The Peelle Company

November 9, 2009

TECHNICAL BULLETIN

- SUBJECT:** LANDING DOOR INTERLOCKS, LANDING DOOR LOCK AND CONTACTS AND NEMA 4/4X/7 GATE CONTACTS.
- EQUIPMENT:** PEELLE INTERLOCK/LOCK AND CONTACT PART NUMBERS 2356, 2356-59, 2356-67, 2332, 2332-32, 2332-29, 2344, 2344-32, 2344-29, 2352, 2352-52, 23526 AND PEELLE GATE CONTACT PART NUMBERS 2376, 2377 & 0320.

033171 CONTACT SPRING

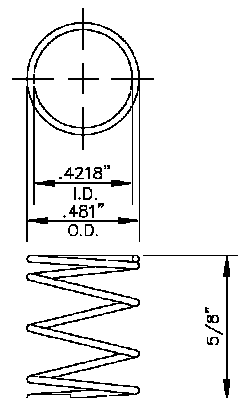
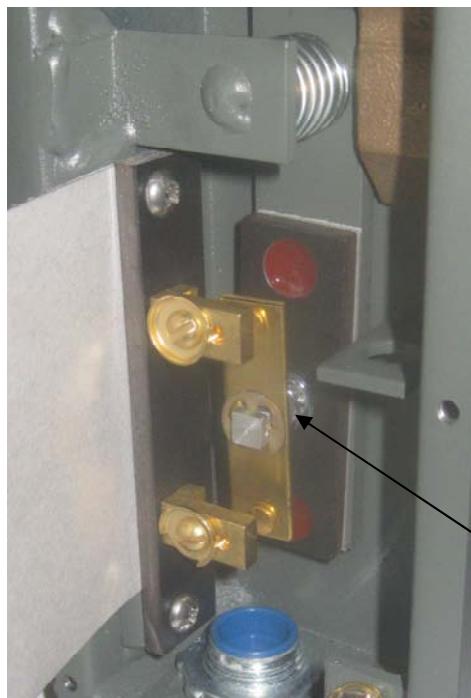
- DESCRIPTION:** WHEN THE CONTACT BAR USED FOR THE DC (DOOR CLOSED) CONTACT OR GC (GATE CLOSED) CONTACT HAS BEEN CHANGED OR MAINTAINED, THE WRONG SPRING OR A DAMAGED SPRING COULD BE USED IN RE-ASSEMBLY. THIS IS A POSSIBLE SAFETY CONCERN.

- ACTION:** IT IS ESSENTIAL THAT WHEN MAINTAINING THE DC/GC CONTACT, A NEW 033171 CONTACT SPRING SHOULD BE USED. PLEASE SEE SKETCH BELOW FOR PROPER SPRING SPECIFICATIONS. PLEASE CONTACT TANIA BUTLER AT (905)846-4545 x218 IF YOU REQUIRE REPLACEMENT PARTS.
